REQUEST FOR INFORMATION	DATE: December 01, 2016	NO.: RFI-368
--------------------------------	--------------------------------	---------------------

Project Name:	15051-Webster University Interdisciplinary Science Building	Project No.: 15051
---------------	---	--------------------

Subject: Window shade pocket detail

12
A0841

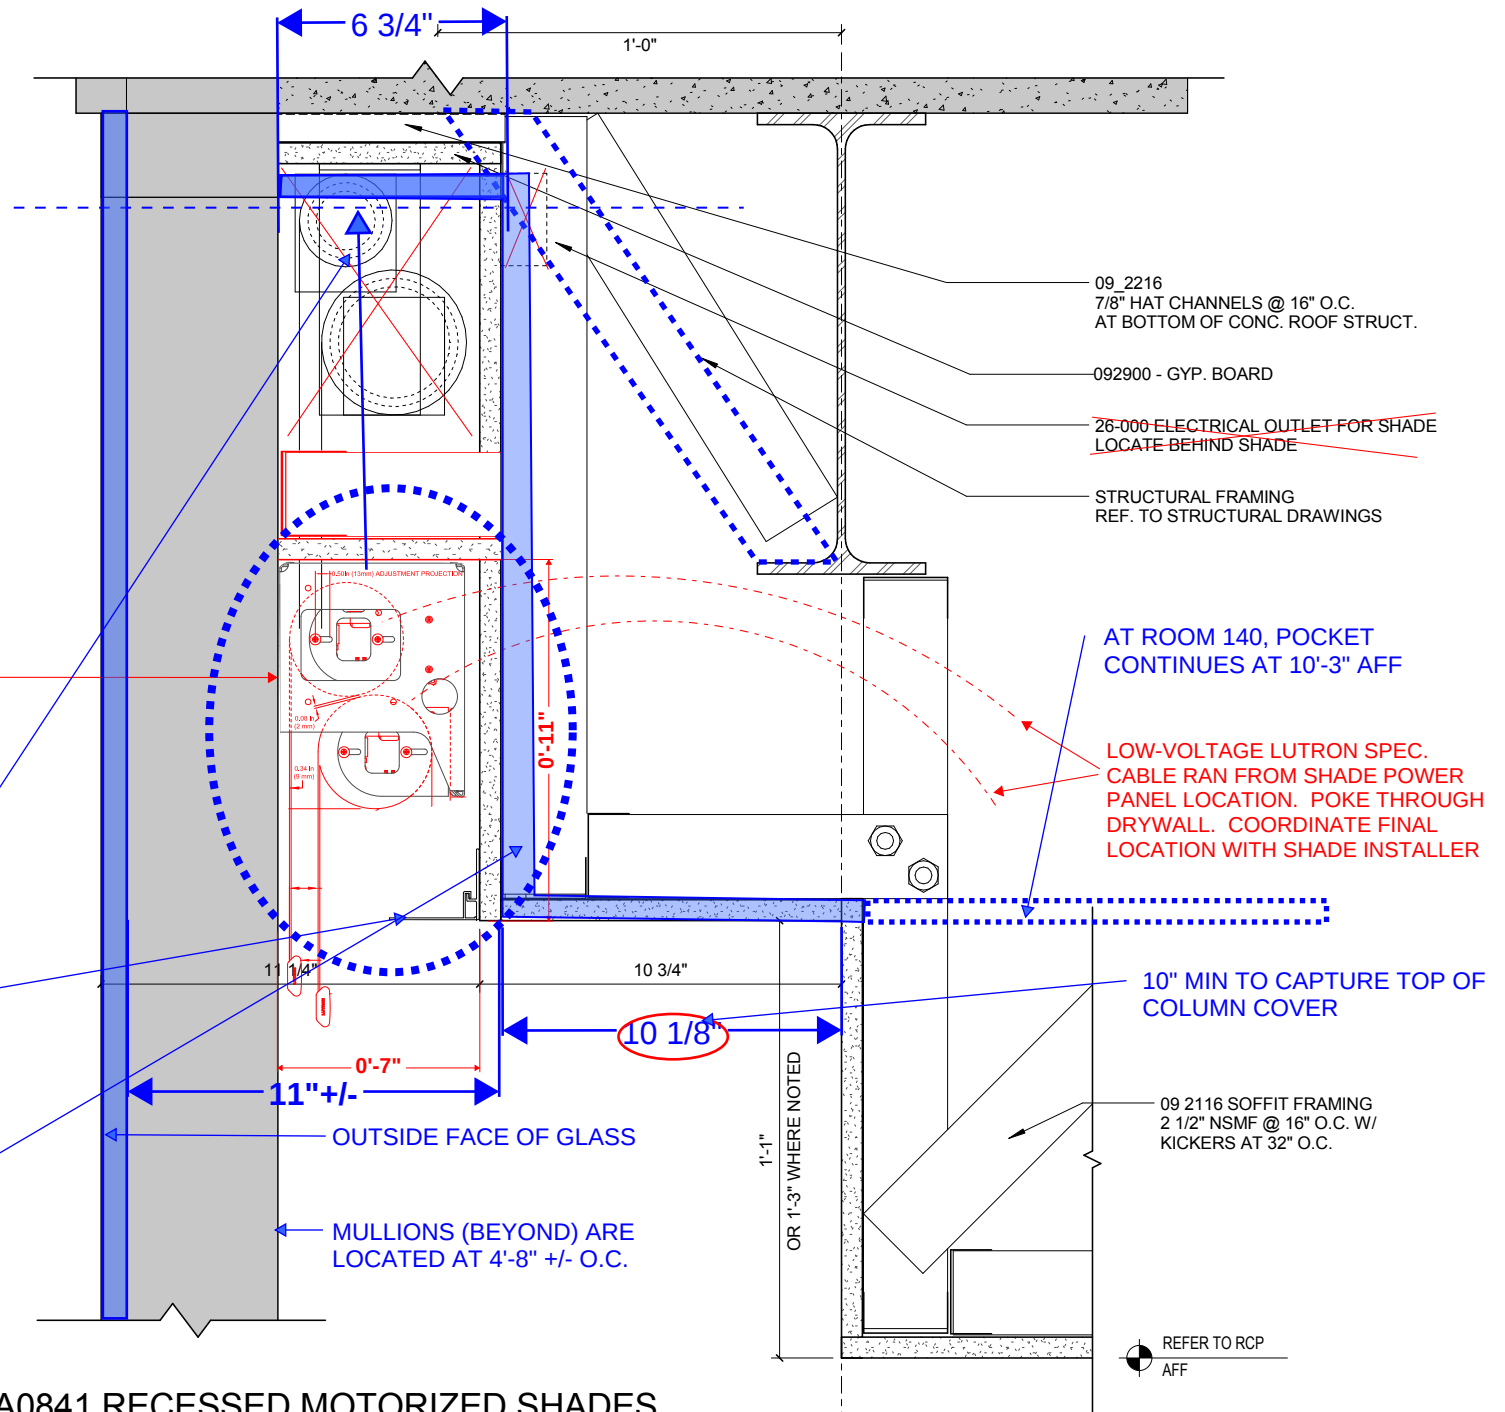
Please see the attached marked up architectural detail 12/A0841. This is the shade pocket detail for the double shades at the exterior windows in Conf. room 140 and Lecture Hall 160 on the first floor, as well as Classroom 276, Classroom 231, Classroom 233 and Lab 235. The shade contractor has made necessary revisions to this pocket detail. Please see the attached drawings and shade manufacturers cut sheet.

Suggestion: Please advise if this will be acceptable.

12/A0841 applies to Lecture Hall 160. Conf Room 140 is similar. No fascia or bottom closure is intended. the shades should be installed exposed . They are at the top of the pocket because of the vision glass in front of them.

The detail provided is not acceptable in these two rooms. We have marked up the attached detail to show a wider pocket to provide additional installation and maintenance space. Narrow width of pocket is being driven by desire to have 10'-3" high soffit extending to edge of column covers. Please confirm that the space is available with the steel angle braces at each room.

122413 TYPE 2 SHADES MOTORIZED DOUBLE ROLLER SHADES: SURFACE
MOUNTED W/ CUSTOM COLOR FASCIA FOLLOW SCHEDULE IN SPECIFICATION: NO FASCIA REQUIRED -
PAINT EXPOSED BRACKETS TO MATCH CURTAINWALL
